SiDroForest ESSD review responses and changes

This document contains the answers to the editorial request (minor revisions) related to the anonymous reviewer's comments (reviewer N°4) in response to the SiDroForest manuscript. Each reviewer's statement is included in regular text and the responses are written below each point in *cursive*.

Response to Figure 13 comments:

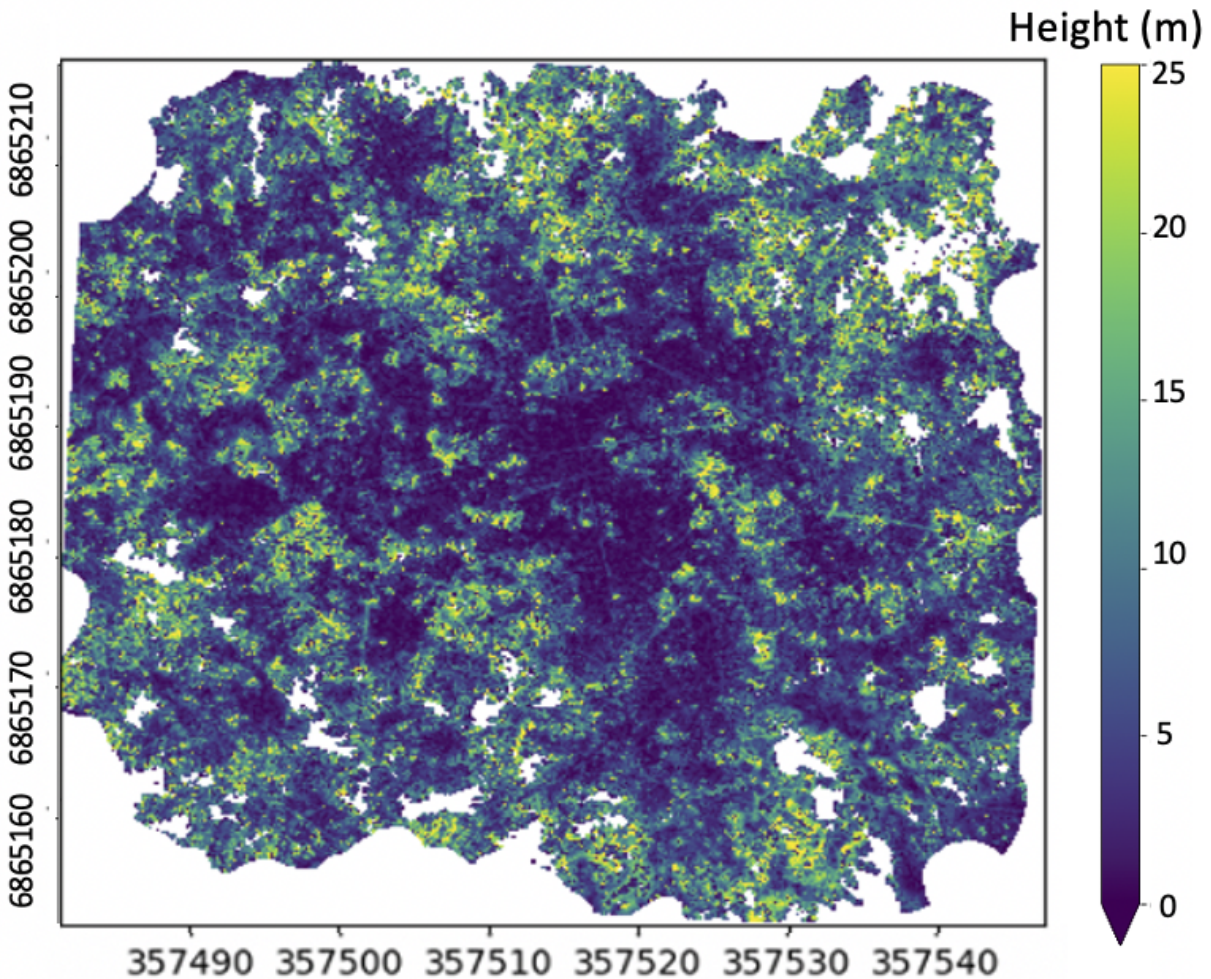
L460, what is the unit of RGM_CHM file? I checked the EN18077_RGB_CHM.tif file and the pixel value ranges from 0.0108667 to 0.637536, which is quite different from Figure 13.

In fact one of the subsets of the UAV product data collection Kruse et al. 2021, <https://doi.pangaea.de/10.1594/PANGAEA.933263> missed the elevation information per pixel in the geotiff files. This refers to the subset of the canopy height model CHM files, we had uploaded the wrong process level of the CHM files and apologize sincerely for this. We have carefully checked every file of the published products - the other data subsets are correct. We have uploaded a corrected CHM version 2 that are now linked via the original dataset:

Response: Yes in this subset of the data publication incorrect CHM files had been regrettably included and are now corrected (see explanation above). The range of EN18077 is now up to 19 m canopy height and the figure 13 showing the color coded CHM in the manuscript is also updated. Thank you very much for checking the data! This was a lot of reviewer work.

Left: orthoimage without crown polygon. Right: detected tree crowns with Q2, most crowns have been detected.

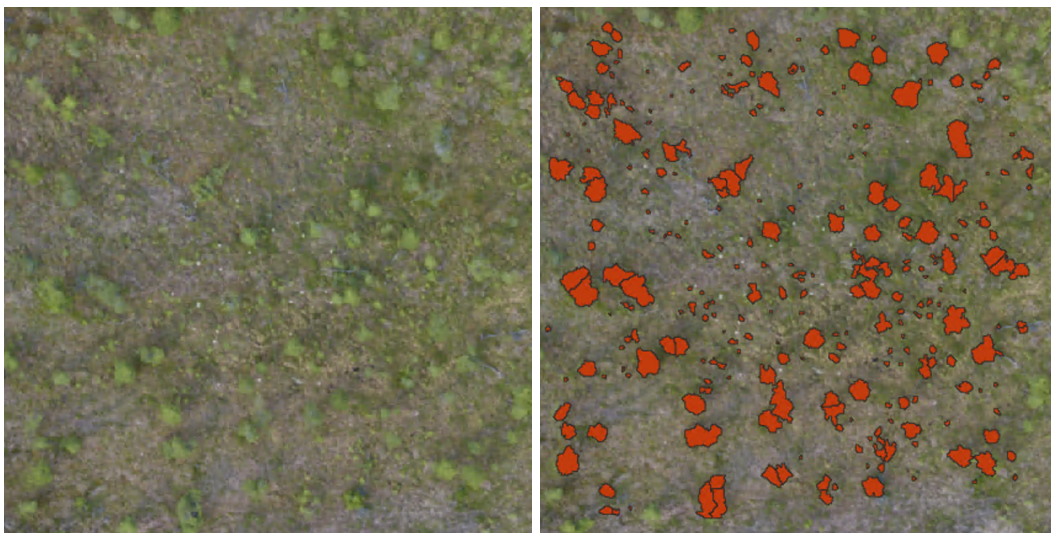
L343, please mention that some plots do not have even Q1 shapefiles (e.g., EN18007).

Response: We downloaded the data from PANGAEA and found that EN18007 has the Quality file, in this case Q2. (As you can see in the image below). If Q1 files are not present, the Q files are of the other, lower Quality categories 2 and 3. Not all plots have trees, the tree crown product and Q files could be only produced when vegetation height was adequate. We added an overview table in the read me file in the 2nd version of the PANGAEA data publication for a more user friendly overview.
